# Work Order ID 79109

Item Name: Crosstube Fwd

Draw Nbr	Revision Nbr
D212-664-141	Rev D (DEO)

DRAWING NO. D212-664-141	TITLE XTUBE ASSY (205/212/412 HI FWD)	REV. D	DART AEROSPACE LTD ENGINEERING ORDER		D.E.O. NO. D212-664-141-D-1	SHEET NO. SHEET 1 OF 2	SCALE NTS
DRAWN	CHECKED	MFG. APPR.	APPROVED	DE APPR.			
DATE 11.04.07	DATE 11.07.11	DATE 11.04.12	DATE 11/04/12	DATE 11.04.12

D212-664-141/-141B  
ASSEMBLY DETAIL

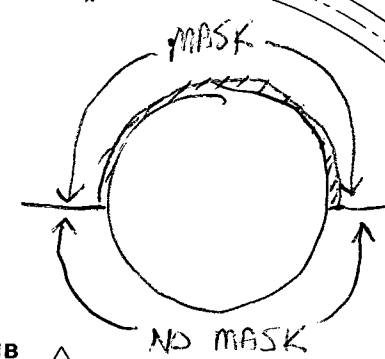
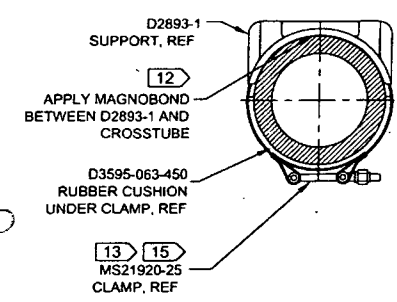
MASK THIS  
AREA BEFORE  
CLEAR COAT

5.00  
MASK

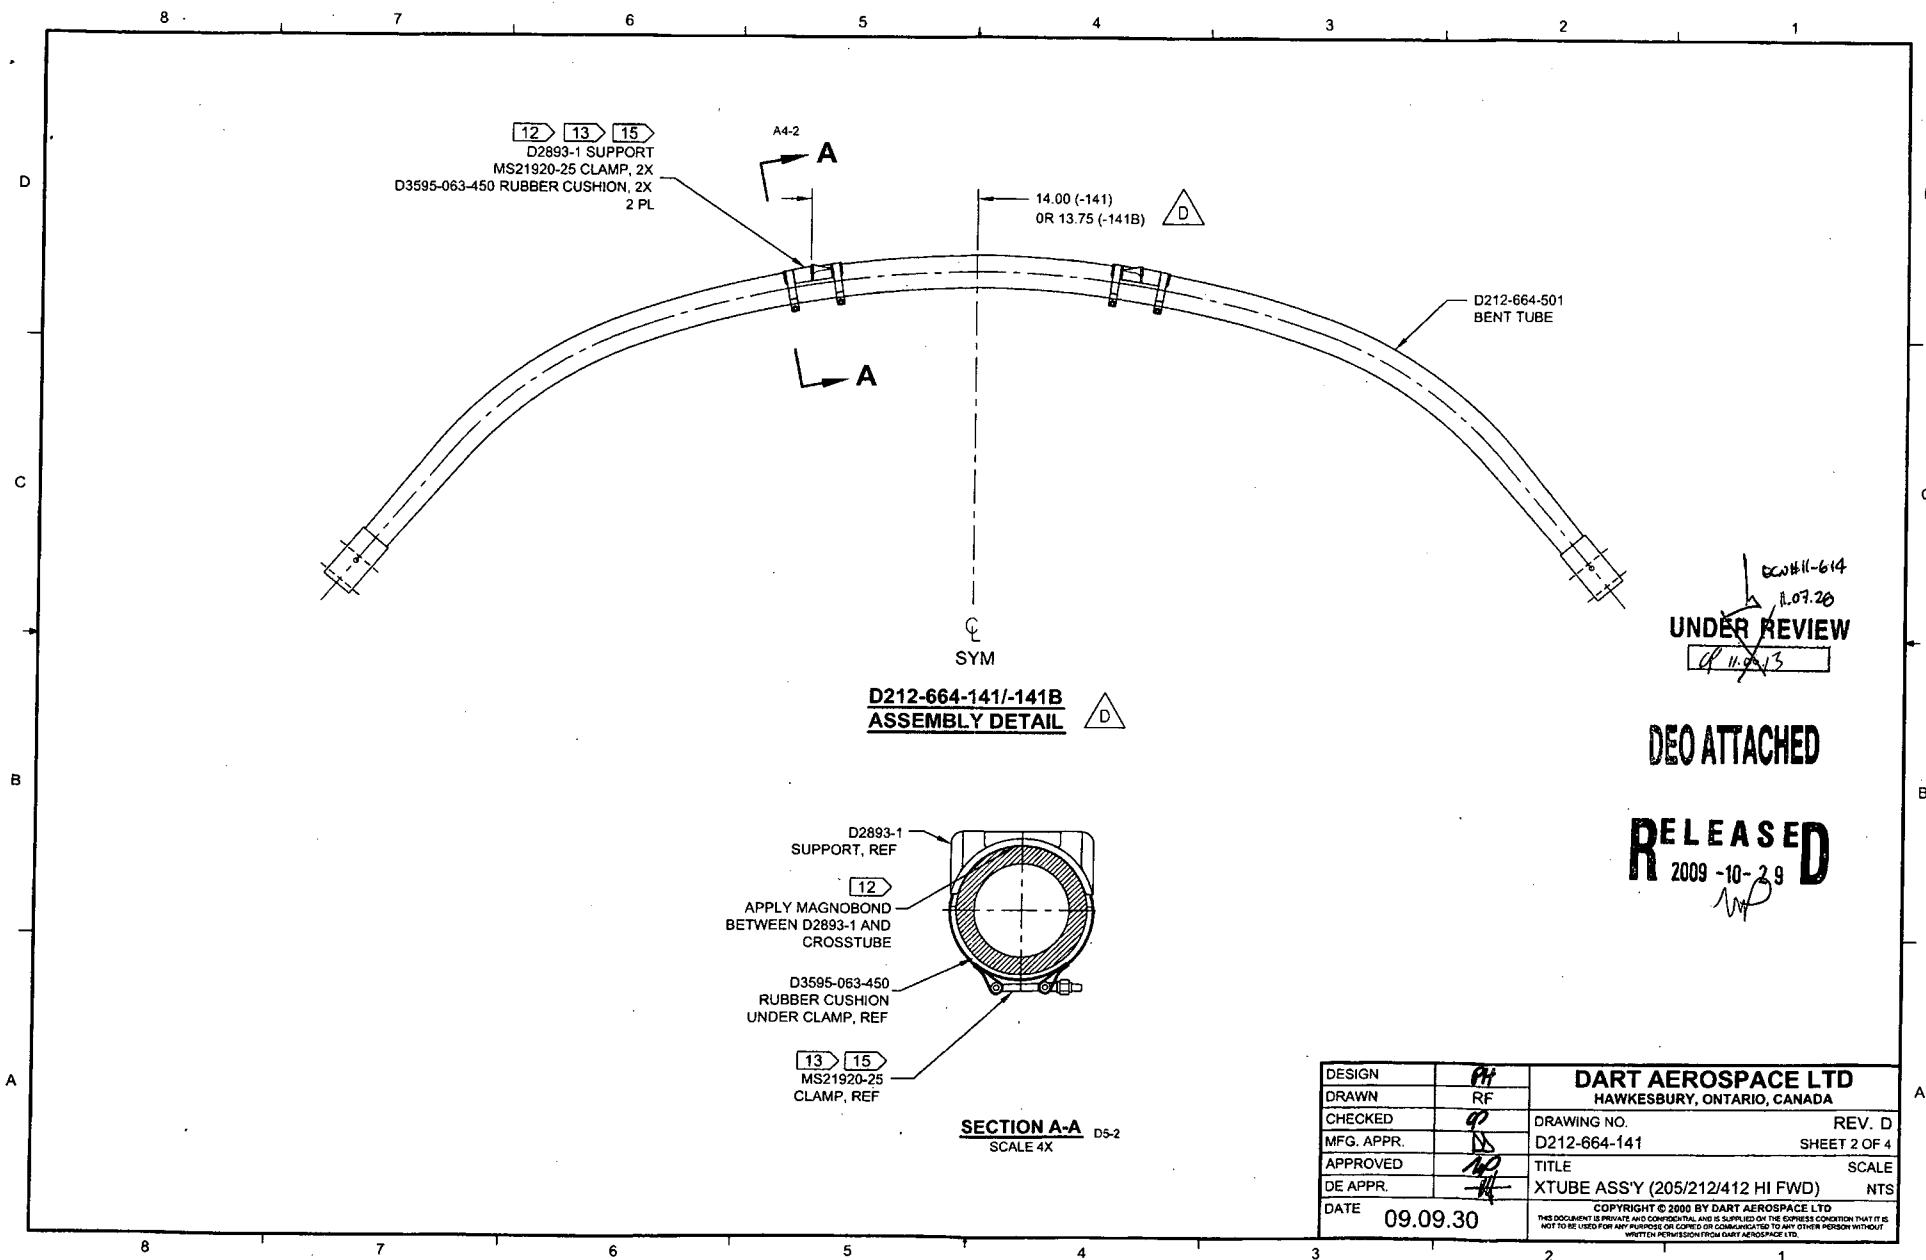
**PURPOSE:**

REPLACE MAGNOBOND WITH PROSEAL.

NOTE 12 & 15, SHEET 1 IS AMENDED AS FOLLOWS:

- 12) INSTALL D2893-1 SUPPORT USING 0.03" TO 0.06" THICK LAYER OF MAGNOBOND 6398 TO THE SURFACE OF D2893-1 THAT WILL BE IN CONTACT WITH THE CROSSTUBE PER QSI 015. LET CURE FOR 12 HOURS AFTER INSTALLATION AND PRIOR TO PACKAGING.
- 15) TORQUE CLAMPS 80 TO 100 IN-LB. ENSURE AT LEAST 1.5 THREADS SHOWING IN SAFETY AND THAT NUT HAS NOT BOTTOMED-OUT AFTER TORQUING.

- 12) TO INSTALL D2893-1 SUPPORT: ABRABE MATING SURFACE OF SUPPORT AND CROSSTUBE WITH 180-GRIT SANDPAPER AND REMOVE RESIDUE WITH MEK (OR EQUIVALENT). APPLY A 0.04" TO 0.07" THICK LAYER OF PROSEAL 890 CLASS B-2 (OR AMS-S-8802 CLASS B-2) SEALANT TO MATING SURFACE OF SUPPORT.
- 15) TORQUE CLAMPS 80 TO 100 IN-LB. ENSURE AT LEAST 1.5 THREADS SHOWING IN SAFETY AND THAT NUT HAS NOT BOTTOMED-OUT AFTER TORQUING. **PRIOR TO PACKAGING, RE-CHECK TORQUE ON CLAMPS AFTER PROSEAL 890 SEALANT HAS CURED FOR 72 HOURS.**

**D212-664-141/-141B  
ASSEMBLY DETAIL**

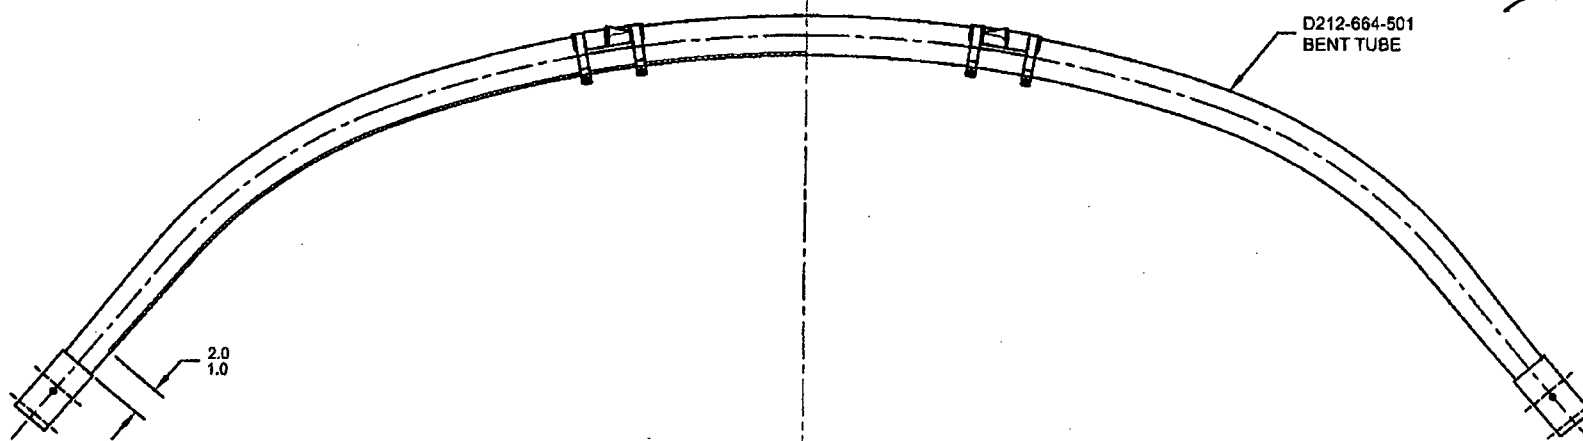
**PURPOSE:**

ADD AN INSPECTION WINDOW TO UNDERSIDE OF CROSSTUBE.

NOTES 2 OF SHEET 1 IS AMENDED AS FOLLOWS:

- 2) FINISH: CHEMICAL CONVERSION COAT PER DART QSI 005 4.1  
PRIME INSIDE AND OUTSIDE PER DART QSI 005 4.2  
PAINT OUTSIDE PER DART QSI 005 4.2

- 2) FINISH: CHEMICAL CONVERSION COAT PER DART QSI 005 4.1  
PRIME INSIDE AND OUTSIDE PER DART QSI 005 4.2  
MASK UNDERSIDE OF CROSSTUBE AS SHOWN (HATCHED AREA) AND  
PAINT OUTSIDE PER DART QSI 005 4.2  
REMOVE MASKING AND APPLY CLEAR COAT

MASK AREA PRIOR TO PAINTING.  
REMOVE MASKING AFTER PAINT  
AND APPLY CLEAR COAT
